3.0 DESIGN OF STRUCTURES, COMPONENTS, EQUIPMENT, AND SYSTEMS

Section 3.1 of the Turkey Point Units 6 and 7 Combined License (COL) Final Safety Analysis Report (FSAR), Revision 8, incorporates by reference Section 3.1, "Conformance with NRC General Design Criteria," of Revision 19 of the AP1000 Design Control Document (DCD).

Figure 3-1 Comparison of applicant's horizontal FIRS with staff FIRS
Also shown are AP1000 CSDRS and the RG 1.60 spectrum anchored at 0.1g.

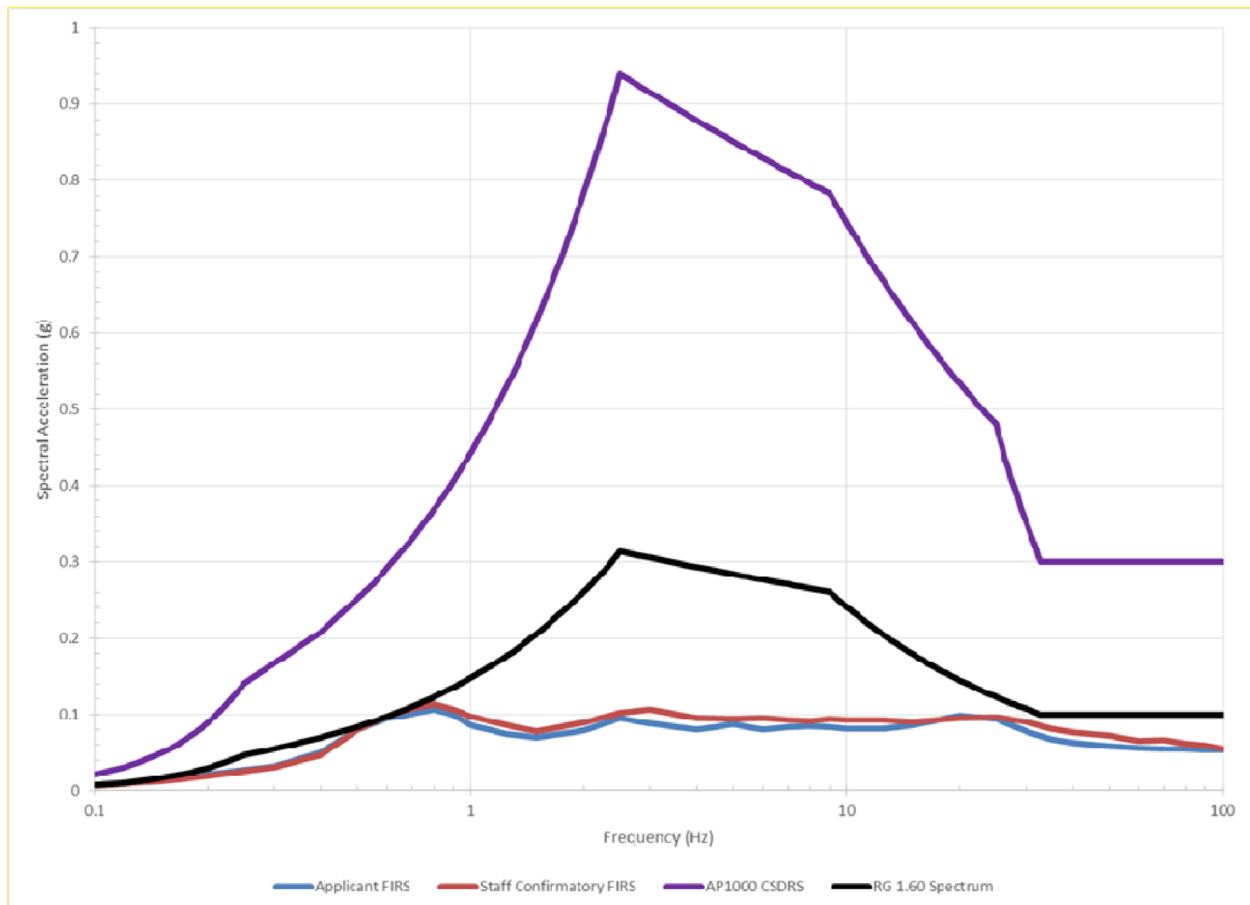
Figure 3-1 compares the applicant's FIRS result with that calculated by the staff, the AP1000 certified design response spectra, and the RG 1.60 response spectra anchored at 0.1g Turkey Point site-specific ground motion applied at the FIRS elevation in the SSI analyses. Overall, the FIRS results are similar, with minor differences attributable to differences in approach and randomization parameters.

The vertical FIRS is obtained by scaling the horizontal FIRS by vertical to horizontal (V/H) ratios from RG 1.60. The horizontal and vertical FIRS were compared to the AP1000 CSDRS and show that the CSDRS envelopes the FIRS. In RAI 4975, Question 03.07.01-12, the staff asked why V/H ratios selected were from RG 1.60 as opposed to V/H ratios from the generic database for the characteristic events associated with the site-specific PSHA.
